333 DEXTER AVE. N.

SEATTLE, WA
DPD#: 3019618

DRB RECOMMENDATION MEETING
WEST DESIGN REVIEW BOARD

JANUARY 06, 2016

THROUGH-BLOCK PLAN & ELEVATION

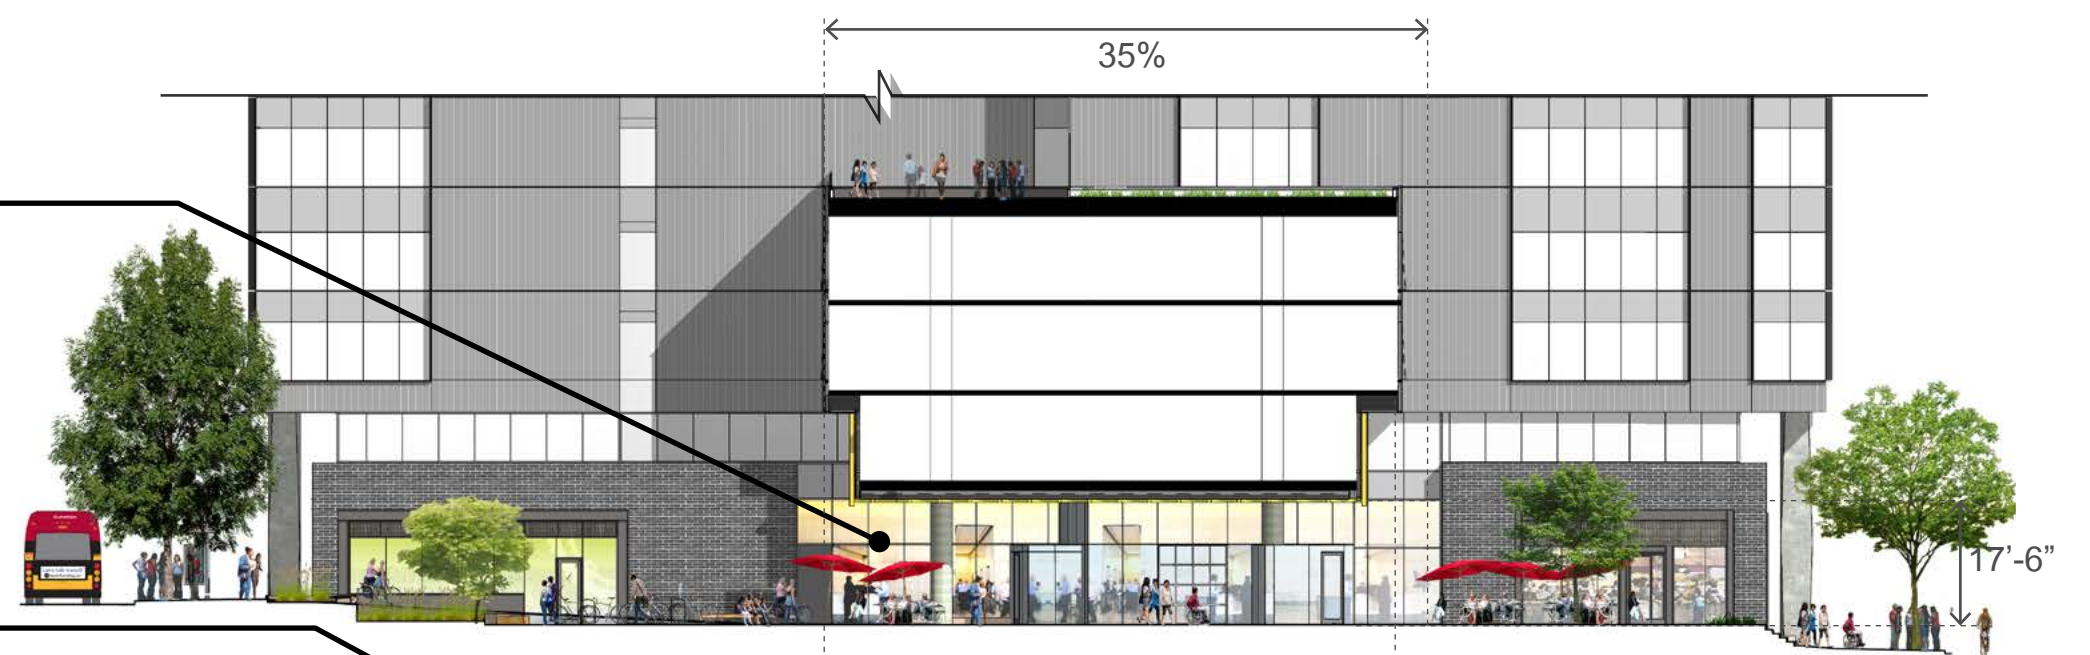
EDG2 COMMENT:
ITEM 3.A Through-block re-designed to be completely open while still maintaining the 'outdoor living room' concept to allow for public gathering

EDG2 COMMENT:
ITEM 3.A Contiguous paving material/pattern, lighting strategy and signage reinforces through-block as open to public

EDG2 COMMENT:
ITEM 3.D 12' wide ramp provides access into through-block & accessible routes all along Dexter.

EDG2 COMMENT:
ITEM 3.E Through-Block width provides setbacks along Harrison St. without sacrificing the success of the Through-Block connection

EDG2 COMMENT:
ITEM 3.F Raingarden gives the building lobbies a visual & acoustic buffer, while offering places to sit for the RapidRide stop

EDG2 COMMENT:
ITEM 2.H Soffit overhead provides shelter from the elements while opening up towards the west to allow for ample daylight
